**TOWN OF DELAFIELD PLAN COMMISSION MEETING**  
**Tuesday, March 5, 6:30 p.m.**  
**Town of Delafield Town Hall W302 N1254 Maple Avenue, Delafield, WI 53018**  
**Amended 3/1/2024@9:00AM**

# Plan Commission Report for March 5, 2022

Requested Action: Approval of site, grading/drainage, landscaping, lighting, architectural plans, and plan of operation

**LSP1.1**

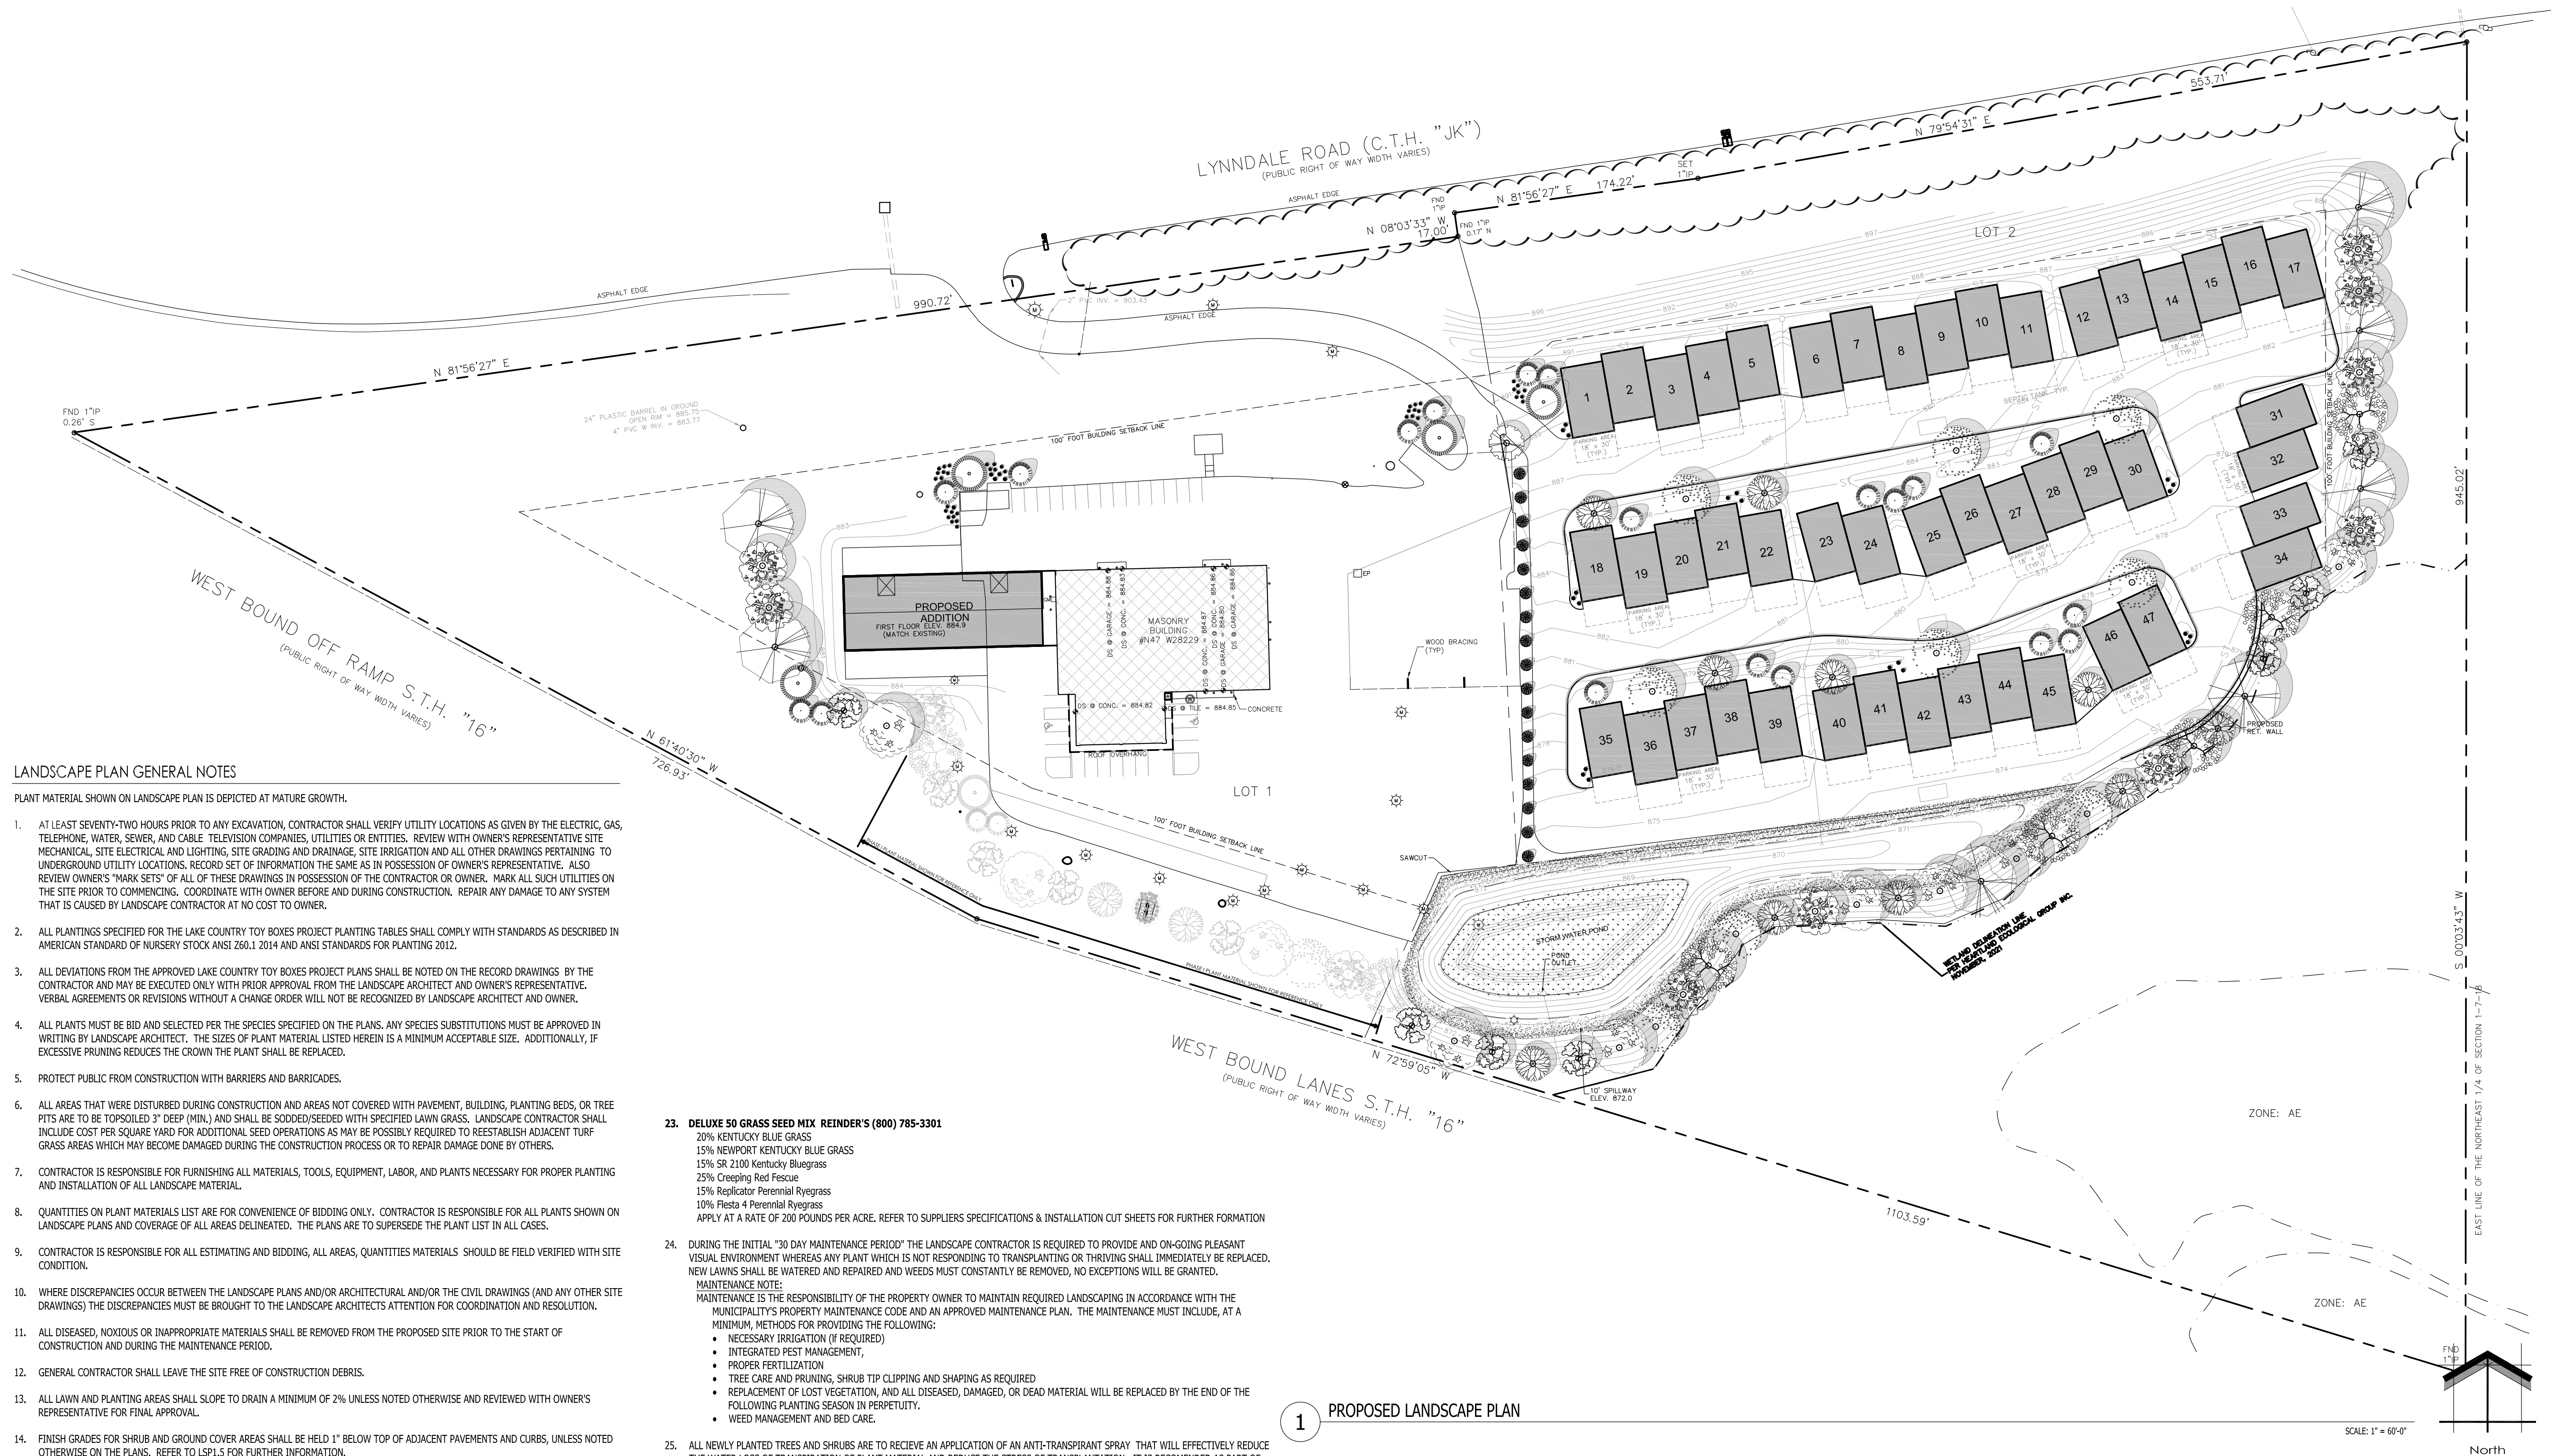
The landscape plan shows proposed landscaping near the entrance of the Toy Box development off of the shared driveway, along the east side of the development extending to the southwest, south of the stormwater pond, trees in the green space north of the middle and southerly tier of storage units and a line of conifers between Lots 1 and 2. Amount and type of plantings are as follows:

A plant schedule indicating sizes and species of trees is included on the landscape plans.
